Environmental Review Team Report

Champagne Property Canterbury, Connecticut

February, 1982

Preliminary Site Plan

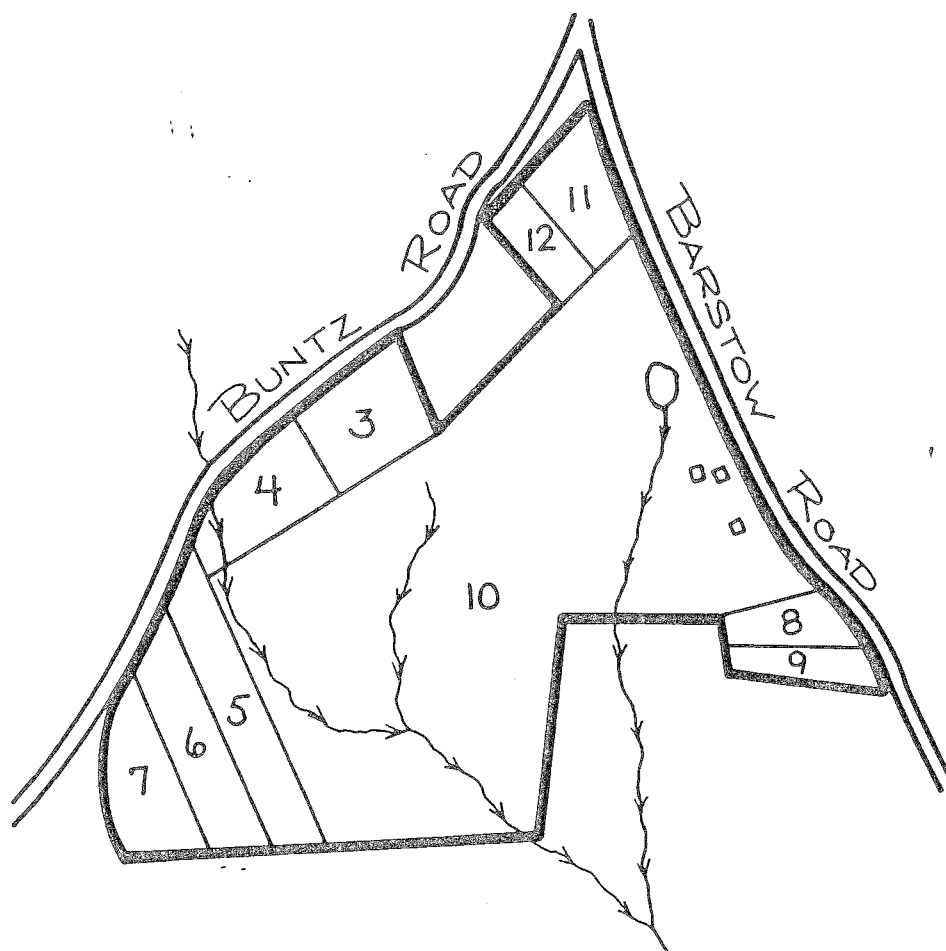
The Team is concerned with the effect of this proposal on the natural resource base of this site. Although severe limitations to development can often be overcome with appropriate engineering techniques, these measures can become costly, making a project financially unfeasible for a developer. This site has several severe development limitations; a large centrally located wetland and brook system, shallow depth of soil to bedrock and generally stony soil conditions. These natural limitations may pose problems in the proper functioning and location of septic systems, the location and construction of driveways and home foundations, and erosion control during construction. Each of these issues is discussed in detail in the following sections of this report. In the Team opinion, those areas with the most severe development limitations were found in the vicinity of Lots 5, 6, and 7; Lots 8 and 9; and Lots 11 and 12.

As initially proposed, the Team soil specialist sees potential for building on lots as follows:

- Lot #3: Access from Buntz Road is favorable; a fairly level driveway could run in along the contour. Although fairly steep, careful architectural design could "fit" a home on the site. Locating an adequate spot for the septic leaching field is a problem. Also rockiness of the lot could affect foundation location and construction.

- Lot #4: The soil 31B is prime farmland. As such, the Windham County Soil and Water Conservation District cannot encourage use of it for building. Any federal loan agency may not subsidize building on this soil. However, except for the probability that an engineered septic system would be necessary, and that foundation footing drains are advisable, this area would be good for one or maybe two homes (one further back from the road). Since the water table in this soil rises to within twenty-four inches of the surface in winter, raised foundations should be considered.

Lots #5,6,7: It may be possible to locate one residence in this area, preferably higher up - where lot 6 and 7 are shown. The land is subject to flooding where lot 5 is shown. Slope and stoniness present the problems. A drive should be installed running with the land's contour.

Lots #8,9: Access from Barstow Road is only available in one location. This was discussed thoroughly during the field review. It is logical to combine these lots due to topography and very limited access.

Lot #10: Restoration of the farmstead is planned. The concept of selling a sizeable tract of land with the old home and barn is admirable.

Lots #11,12: The outcrops of ledge, general stoniness, severe slope, and wetland at the toe of the slope (lot 11) severely affect the buildability of these lots. Filling around a home and stabilization of any fill used would be inevitable. It is questionable whether or not the Northeast District Department of Health would find a suitable location for a septic system. Bringing a driveway in from Buntz Road will be a problem, fill will probably be necessary. Sight visibility from a driveway entering the road should be considered. Possibly one residence could be built on these two lots.

In regard to the preliminary layout of lots, the Team Sanitarian has reservations concerning the feasibility of some lots for sewage disposal. In particular are the lots (#8 and 9) at the south end of Barstow Road, the corner (#11) lot at Barstow and Buntz Roads and lots (#6 and 5) near the west end of Buntz Road. While no actual soil testing has been done, careful evaluation of the above noted lots should be made in order to locate possible suitable areas of sufficient size to accommodate both primary and reserve sewage systems. In general, it would appear that some revisions or modifications to the plan for lot layouts should be made.

Excerpt : Canterbury Plan of Development (1976)

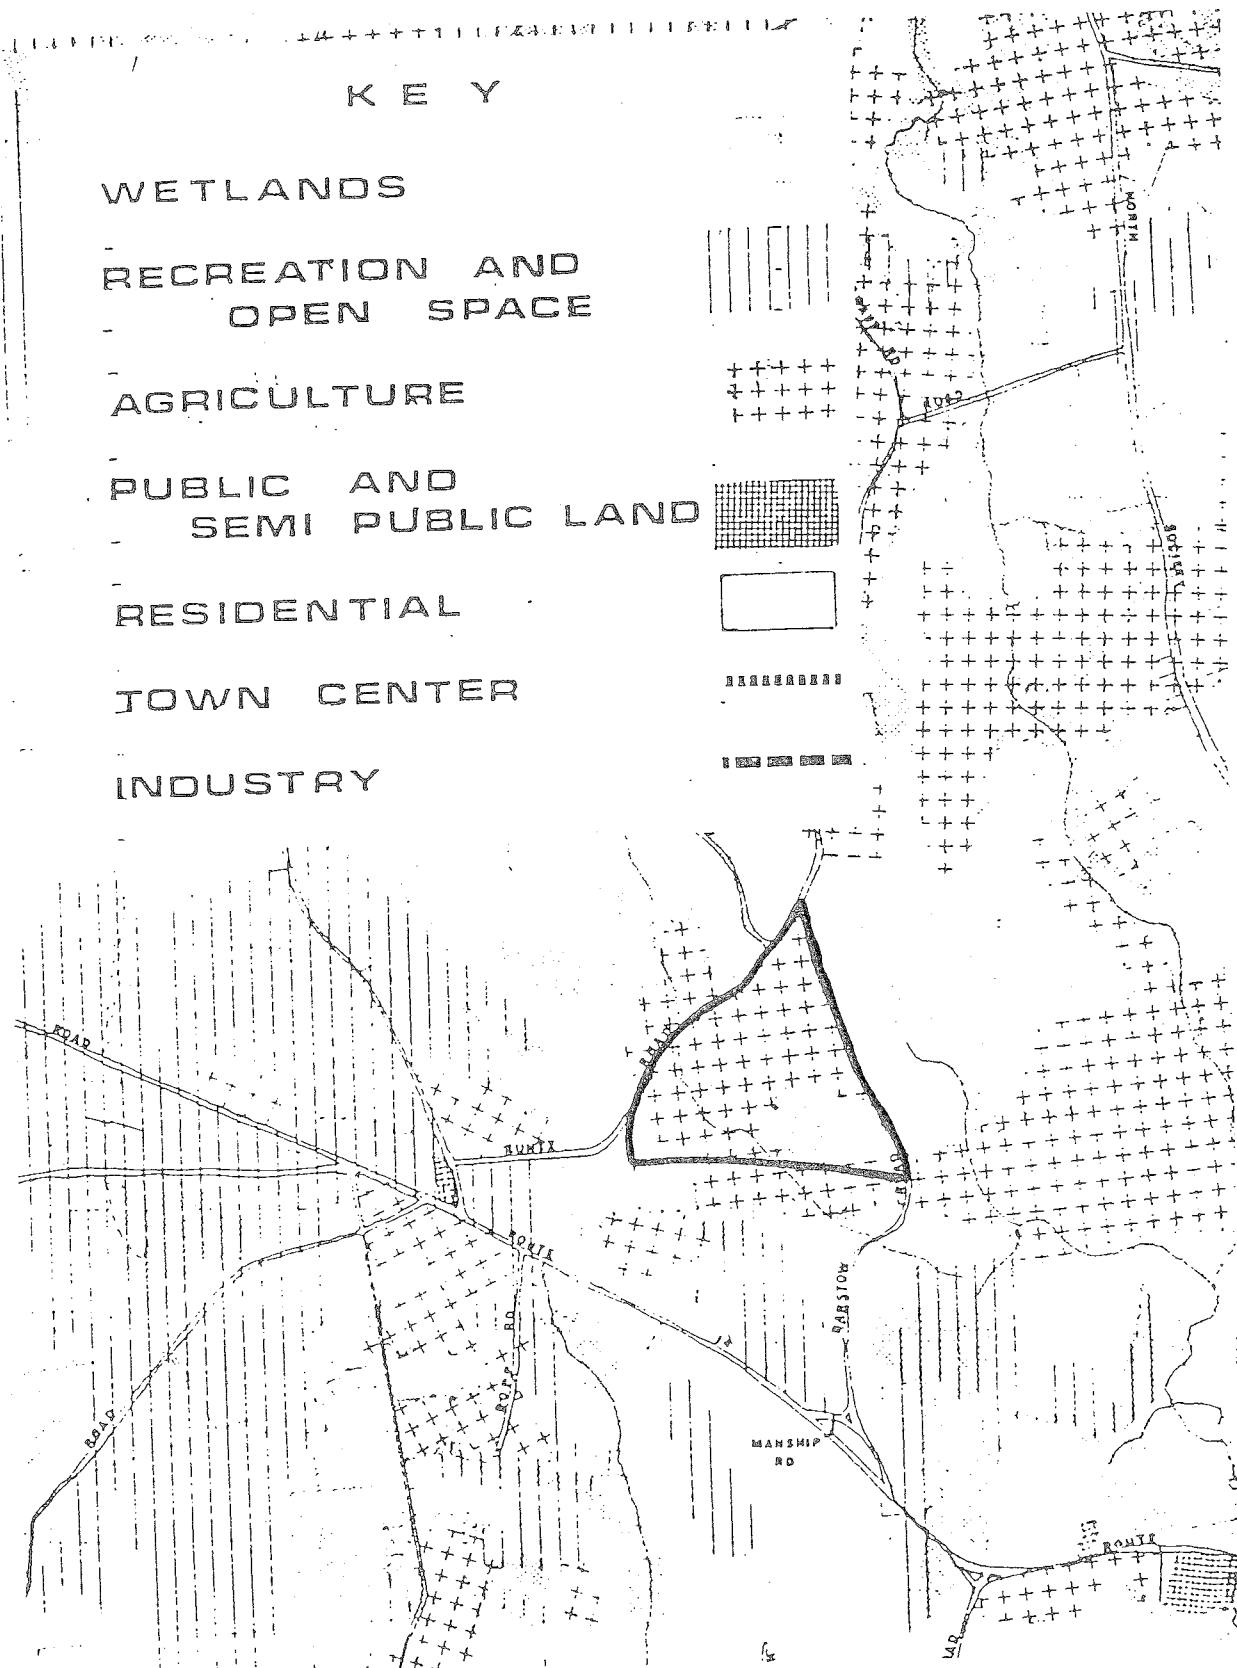
The development of this site as a subdivision is not in conformance with the town plan of development (prepared in 1976). Canterbury's plan of development contains the following objectives which apply to the site:

The proposed site is specifically designated on the plan of development suggested land use maps as a desired agricultural area (see accompanying illustration).

The site constraints present on this property combined with the town's own plan of development seem to indicate that a subdivision at this location is not particularly desirable.

Soils

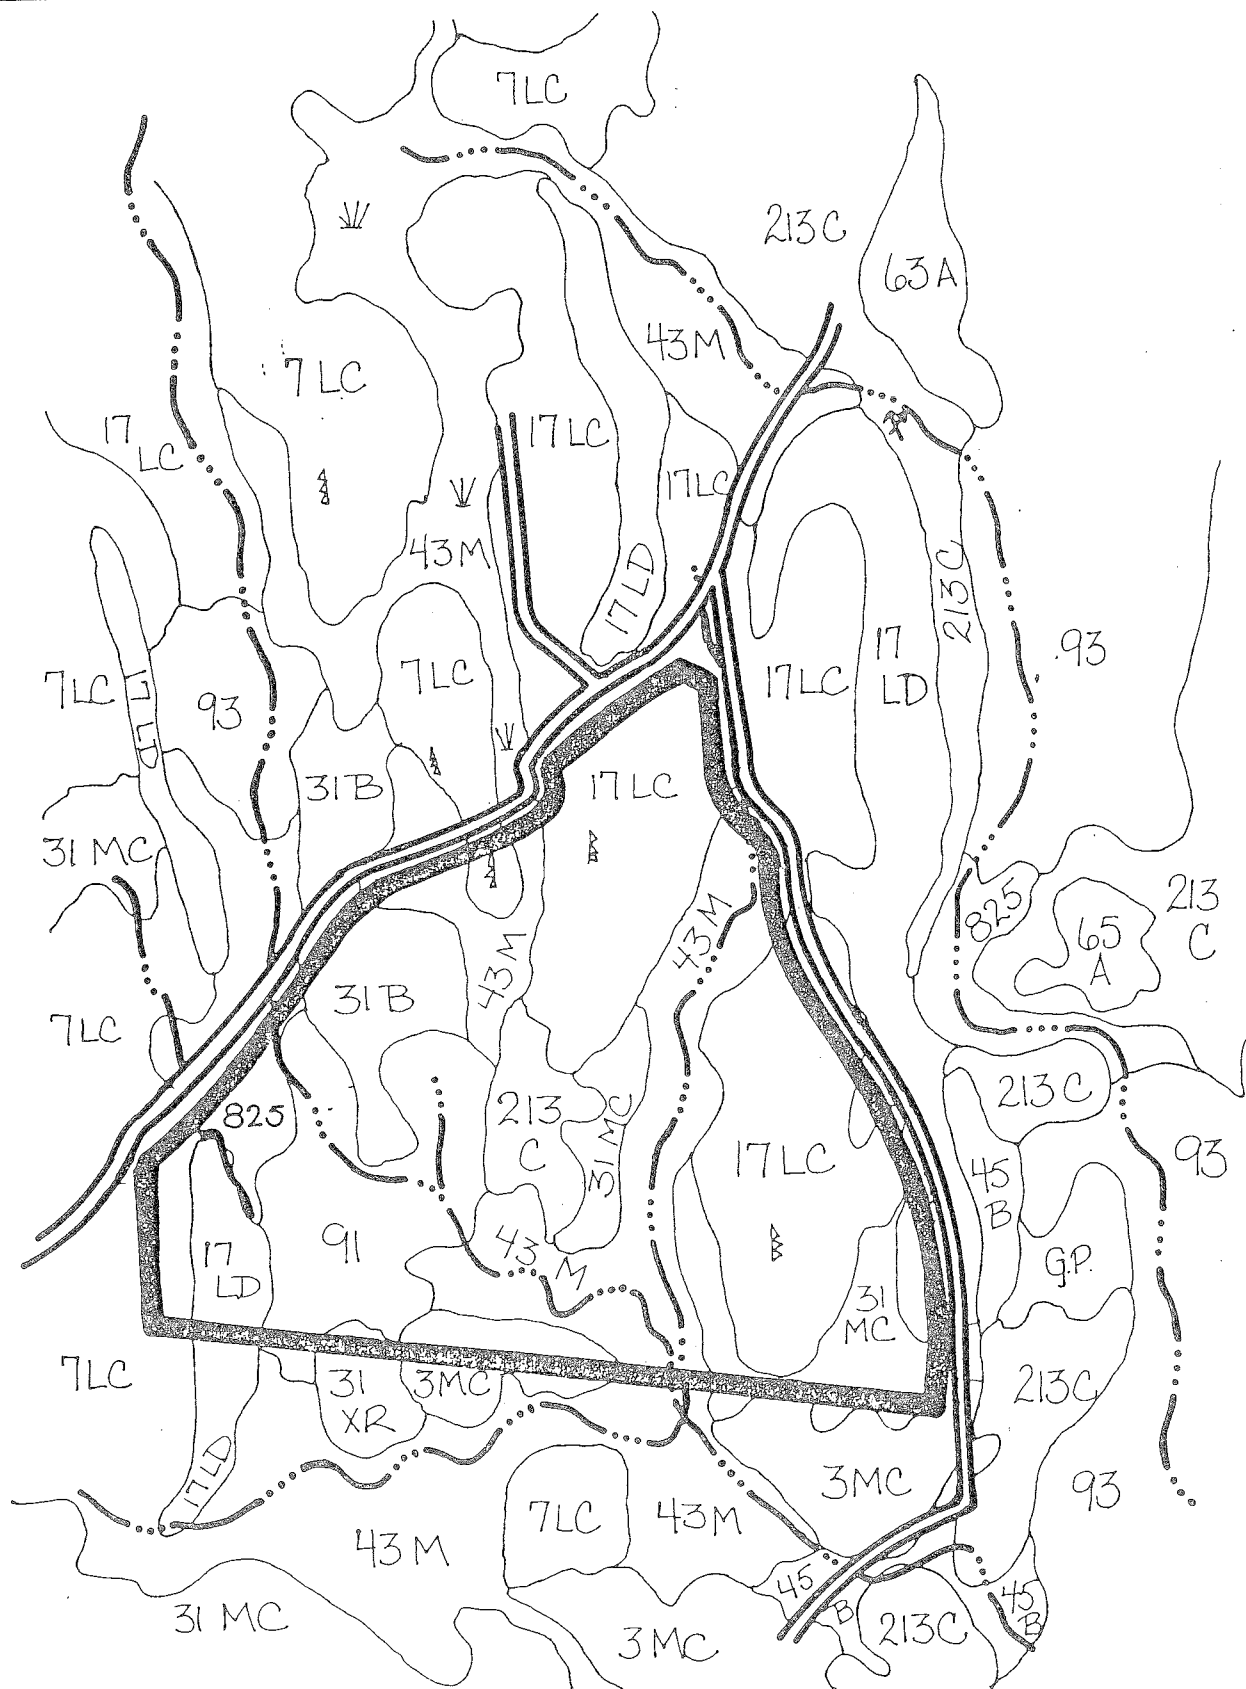
The soils distribution is shown on the map developed from the original aerial soils maps. Soil limitations and ratings for development are included in the Appendix to this report. Even soils other than wetlands have moderate to severe limitations for building due to seasonal wetness, slope, or stoniness. The Woodbridge fine sandy loam (31B) although wet due to a perched water table in winter and spring months, is recognized as prime farmland by USDA standards. A few acres of this soil are present on the site along Buntz Road. Wetlands designated by soil map units 43M, 91, and 825 interlace the property. The Rippowam (825) soil is subject to flooding from Buntz Brook during severe storm events and snow melt conditions. Storm water will flood periodically on the other two wetlands soils.
